## RESPONSE TO REQUEST FOR ADDITIONAL INFORMATION

### APR1400 Design Certification

RAI No.: 287-8272

SRP Section: 09.01.02 – New and Spent Fuel Storage

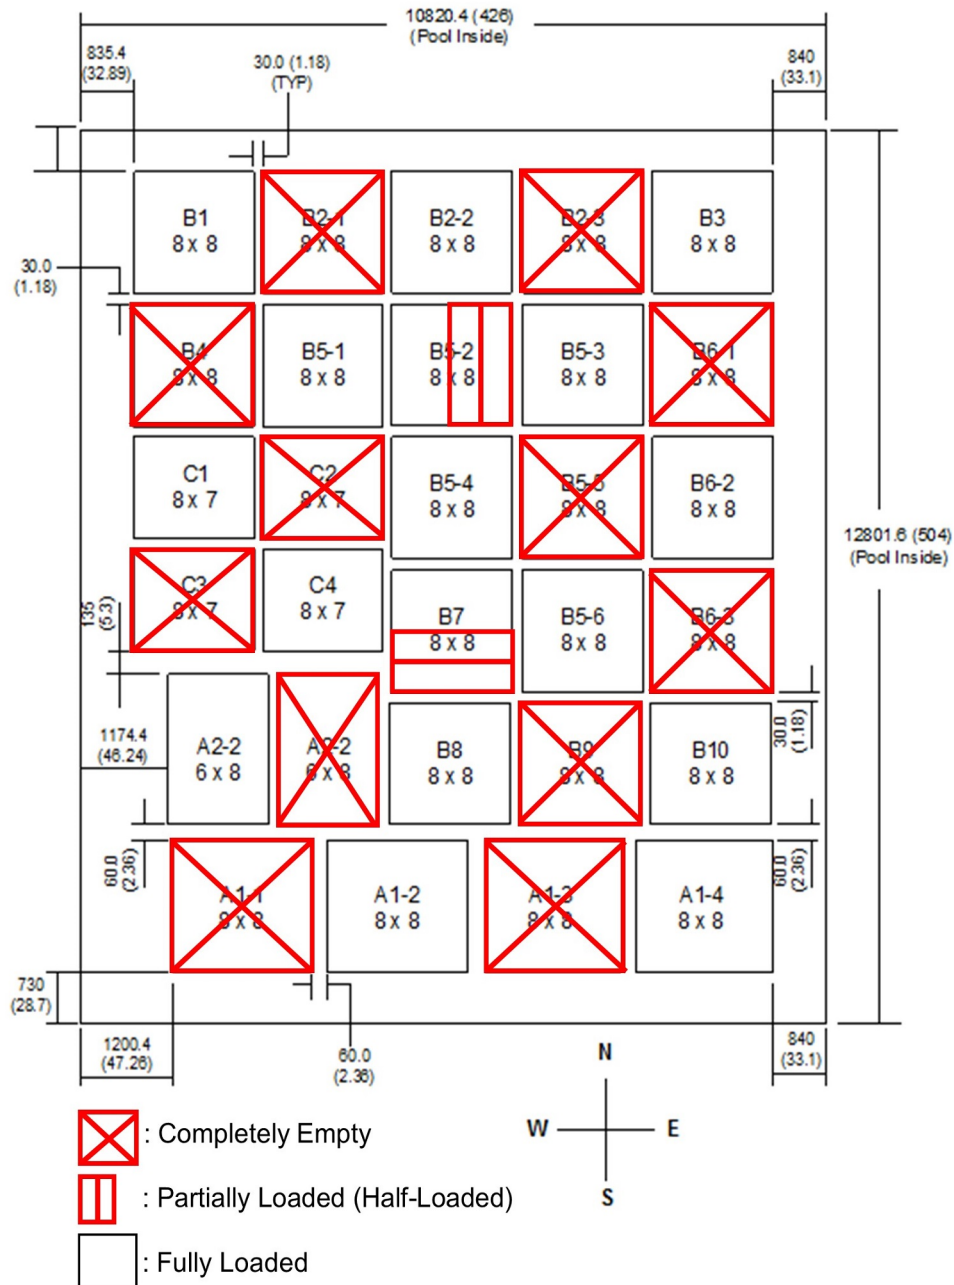
The 10 CFR Part 50, Appendix A, General Design Criteria (GDC) 1, 2, 4, 5, 63, and 10 CFR 52.80 (a) provide the regulatory requirements for the design of the new and spent fuel storage facilities. Standard Review Plan (SRP) Sections 9.1.2 and 3.8.4, Appendix D describes specific SRP acceptance criteria for the review of the fuel racks that are acceptable to meet the relevant requirements of the Commission's regulations identified above. In DCD Tier 2, Section 9.1.2.2.3, "New and Spent Fuel Storage Rack Design", the applicant stated that "The dynamic and stress analyses are performed as described in report APR1400-H-N-NR-14012-P & NP". In the report APR1400-H-N-NR-14012-P, Rev.0, Section 3.6, "Dynamic Simulations", it is stated that "The storage rack configurations at the full loading are considered in the dynamic simulations." This sentence implies that assuming every rack with the full loading in the seismic or impact analyses results in a conservative design. It is not apparent to the staff that assuming the full loading for every rack is conservative. For example, consider the following scenario: Assume a fully loaded rack subjected to an earthquake does not slide; now consider two racks with one rack empty; and the other rack fully loaded. During the same earthquake, the lighter rack slides because its friction force at the base is now less than if it were fully loaded. The fully loaded one by itself would not slide; however, it may slide due to the impact from the lighter rack; thus, the whole system (the lighter rack and the fully loaded rack) slides. Based on the above example, the applicant is requested to provide a technical rationale and the results of any study performed to demonstrate that the assumption of all fully loaded racks will always result in a conservative design. Otherwise, the applicant is requested to consider appropriate loading patterns in the analyses. The loading patterns considered should include the case of all racks completely empty to demonstrate that the racks and liner of the spent fuel pool would not be damaged due to the impact.

22 on Table 3-6 of the attachment describe all racks are empty. Runs 23 and 24 describe a "mixed loading" configuration wherein the number of fuel assemblies stored in each rack varies. Below figure shows a mixed loading configuration.

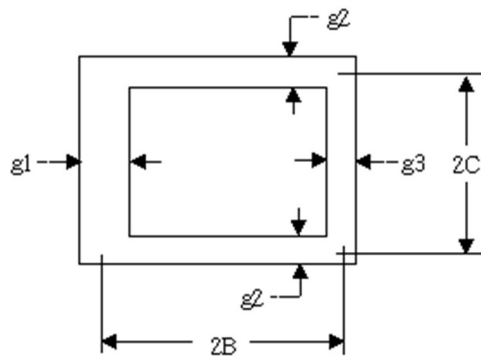
1. The 10 CFR Part 50, Appendix A, General Design Criteria (GDC) 1, 2, 4, 5, 63, and 10CFR 52.80 (a) provide the regulatory requirements for the design of the new and spent fuel storage facilities. Standard Review Plan (SRP) Sections 9.1.2 and 3.8.4, Appendix D describes specific SRP acceptance criteria for the review of the fuel racks that are acceptable to meet the relevant requirements of the Commission's regulations identified above. In DCD Tier 2, Section 9.1.2.2.3, "New and Spent Fuel Storage Rack Design", the applicant stated that "The dynamic and stress analyses are performed as described in report APR1400-H-N-NR-14012-P & NP". In the report APR1400-H-N-NR-14012-P, Rev.0, Section 3.1.2.3 "Hydrodynamic Mass", the staff notes that the Applicant did not describe the hydrodynamic mass under the baseplate of each rack. The SRP 3.8.4 Appendix D section I.5, "Design and analysis Procedure" requires that the effect of effective mass from submergence in water should be quantified. In accordance with SRP 3.8.4 Appendix D section I.5, the Applicant is requested to (1) clarify whether the hydrodynamic mass under the rack baseplate of each rack has been considered in all nonlinear seismic analyses and (2) provide the methodology for calculating this hydrodynamic mass. If the hydrodynamic mass under the base plate of each rack is not considered in the nonlinear dynamic analyses, the applicant is requested to provide the technical basis and justification to show that ignoring the hydrodynamic mass under the baseplate of each rack is conservative. The second part of Subsection 3.1.2.3 states "(2) Hydrodynamic masses between Rack-to- Rack and Rack-to-Pool Wall are calculated based on height of rack, density of fluid and gap of adjacent racks, assuming that the fluid is filled between two objects." The applicant is requested to provide a technical reference to any recognized method for this calculation. Also, describe how changes in the gap during seismic response affect the gap-dependent hydrodynamic mass and the subsequent seismic response due to the revised hydrodynamic mass. This could potentially be significant for low coefficient of friction cases where more sliding is expected.

- (1) The hydrodynamic mass under the rack baseplate of each rack is considered in the dynamic analysis. The dynamic simulation list and analysis results including the hydrodynamic mass under the rack baseplate of each rack are shown in the response for Question 09.01.02-16.
- (2) The hydrodynamic mass under the rack baseplate of each rack is calculated using the following formula in accordance with Table 1 of the effect of liquids on the dynamic motions of immersed solids of Reference 5 in APR1400-H-N-NR-14012-P.

$$M_{\text{baseplate}} = K (\pi \rho a^2 b / 4)$$

Where,  $K = 0.478$ ,  $a$  and  $b$  are the dimensions of the rack baseplate, and  $\rho$  is density of fluid.

**Figure 4-1 Schematic of the Straight Shallow Drop**

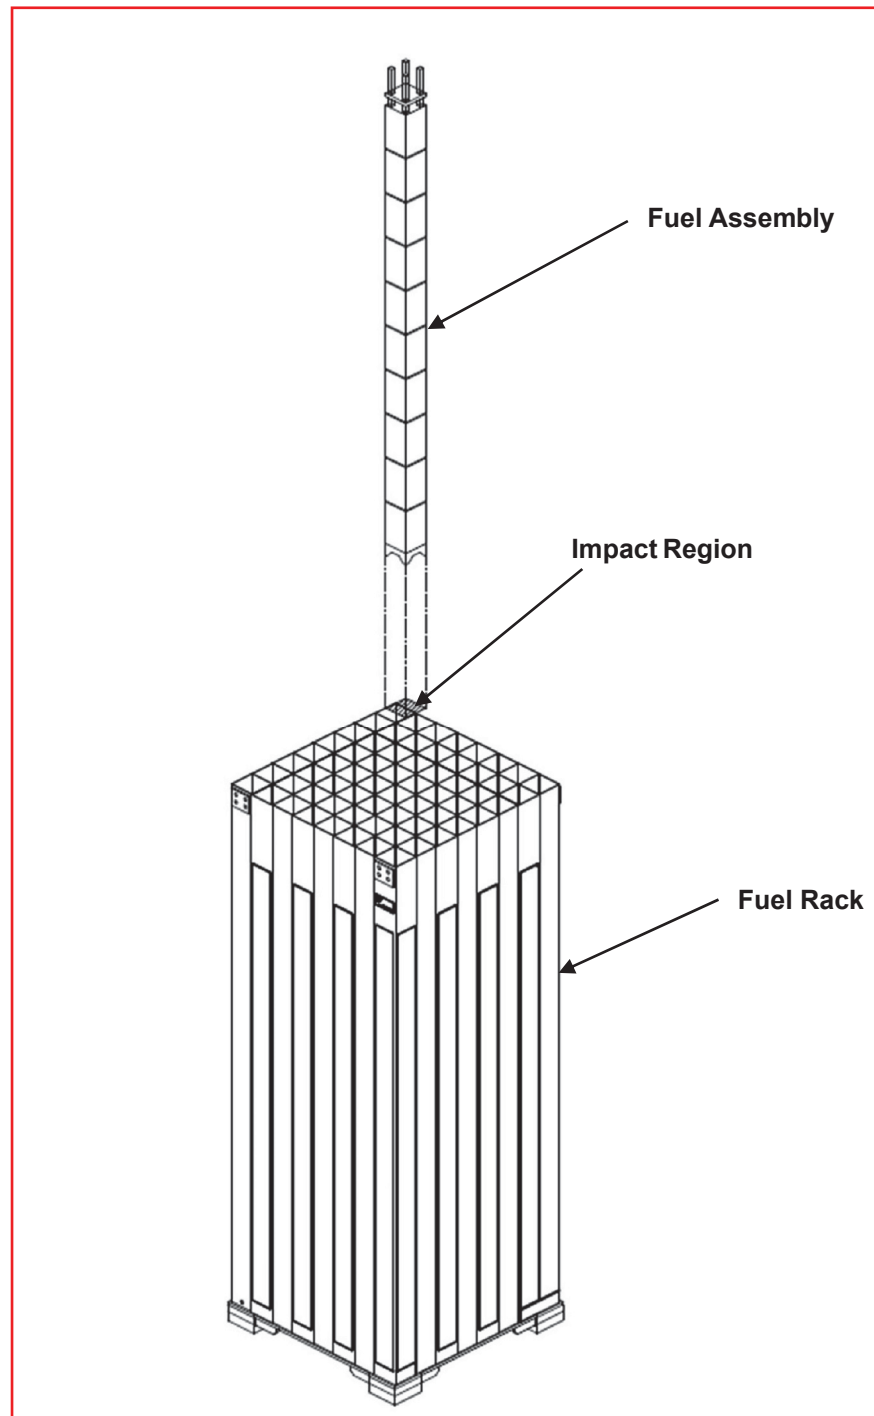
1. The 10 CFR Part 50, Appendix A, General Design Criteria (GDC) 1, 2, 4, 5, 63, and 10CFR 52.80 (a) provide the regulatory requirements for the design of the new and spent fuel storage facilities. Standard Review Plan (SRP) Sections 9.1.2 and 3.8.4, Appendix D describes specific SRP acceptance criteria for the review of the fuel racks that are acceptable to meet the relevant requirements of the Commission's regulations identified above. In DCD Tier 2, Section 9.1.2.2.3, "New and Spent Fuel Storage Rack Design", the applicant stated that "The dynamic and stress analyses are performed as described in report APR1400-H-N-NR-14012-P & NP". In the report APR1400-H-N-NR-14012-P, Rev.0, Section 4.3 "Analysis Method", the applicant presented empirical methodologies to analyze the straight shallow and deep drop accidents. The applicant is requested to provide a validation and verification of the proposed empirical methodologies for nonlinear impact phenomena in order for the staff to evaluate whether the proposed methodologies are conservative in predicting the nonlinear deformations of the rack and the rack baseplate, and the impact force on the rack pedestal that is transmitted to the liner and the concrete structure of the spent fuel pool. A nonlinear dynamic analysis for the impact effects of drop accidents, considering a finite element model of the spent fuel rack, rack base plate, a fuel assembly and the pedestal support using appropriate shell, beam, and solid body elements is one approach acceptable to the staff.

APR1400-H-N-NR-14012-NP, Section 4.5, Table 2-1, Table 2-2 and Figure 4-1 will be revised as shown in the attachment.
